Sent: 16/12/2019 12:03:36 AM
Subject: 54 Golf Pde DA2019/1284 Submission Response OGIER 52 Golf Pde
Attachments: 54 Golf DA Application Response Final.pdf;

RE: Submission re 54 Golf Parade Development Application Reference # DA2019/1284

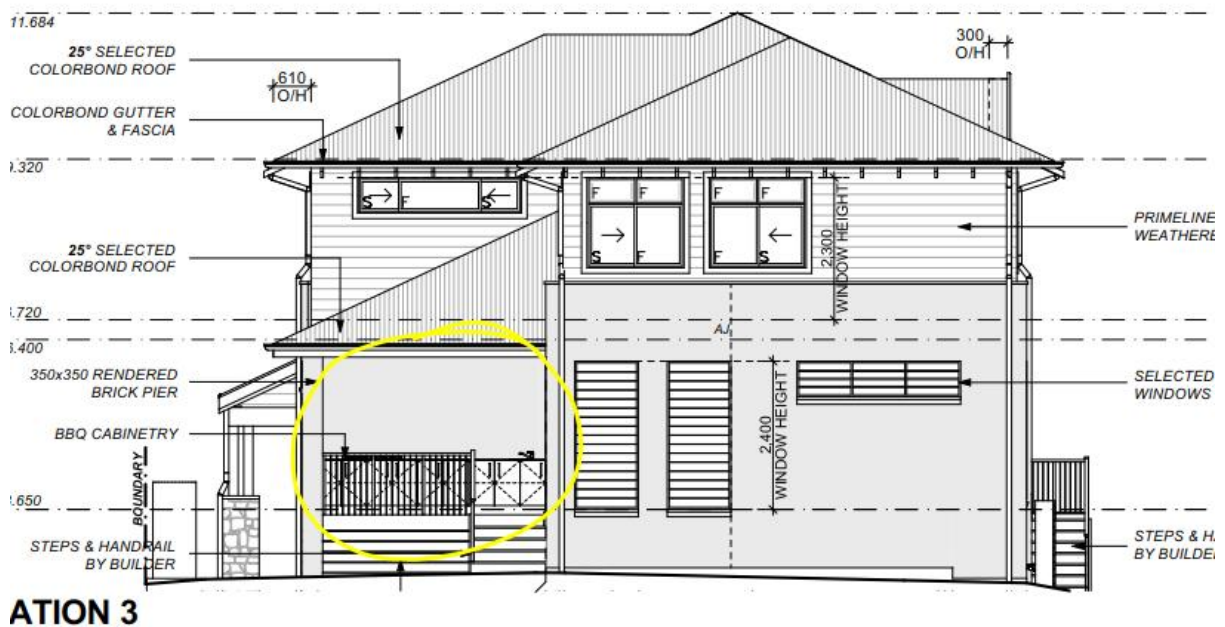
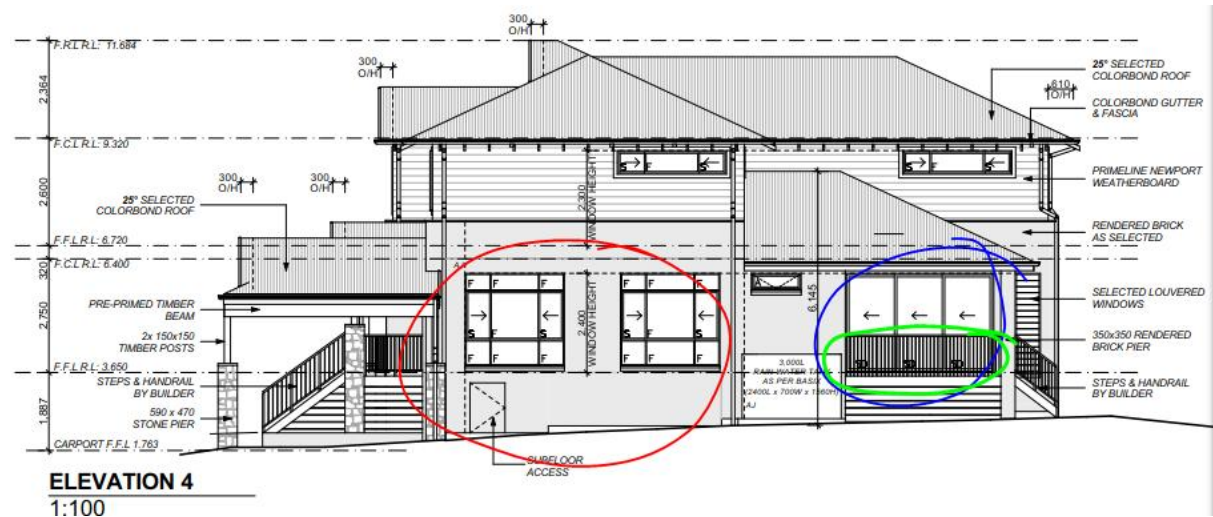
- The Manly Development Control Plan 2013 states "development should be designed to: avoid elevated structures constructed in extended columns that dominate adjoining sites such as elevated open space terraces...". The DA has an elevated alfresco terrace/deck that will look right into our living area and backyard. Due to its elevation it will be higher than the fence and will infringe our privacy.
- Off the deck are glass sliding doors which directly face into our property (see area circled 'blue' in above picture). Even from inside their house they will be able to look directly into our backyard.

Request: We request the deck have blocked out sides/screening. On the DA is a low see through handrail (see green circled area on plans pictured above) which is completely inadequate for privacy and only 2.4m from our house. Block out screens are essential. Or our preference is the deck should be moved to the left hand (western) side of the property where it does not sit directly next to our living space and instead to Balgowlah Rd where there is no other property.

- There are two oversized extremely large windows facing directly into our property on the east hand side (see circled red section in plans in above picture and window schedule highlighted below). We request the two oversized windows on the right hand side be reduced in size. They look directly into the side of our house and even though we have frosted windows we often open these windows and will be looking right into our house!

Request: We request that the glass sliding doors are redesigned to face the rear boundary (highlighted in yellow in the second picture above). The rear boundary is where they have the most 'garden' space, it makes sense that the sliding door windows are facing the rear instead of the direction of our property.

Request: The windows should be amended to standard size, they should begin at sill height and be opaque. This is to protect our privacy and solar access.
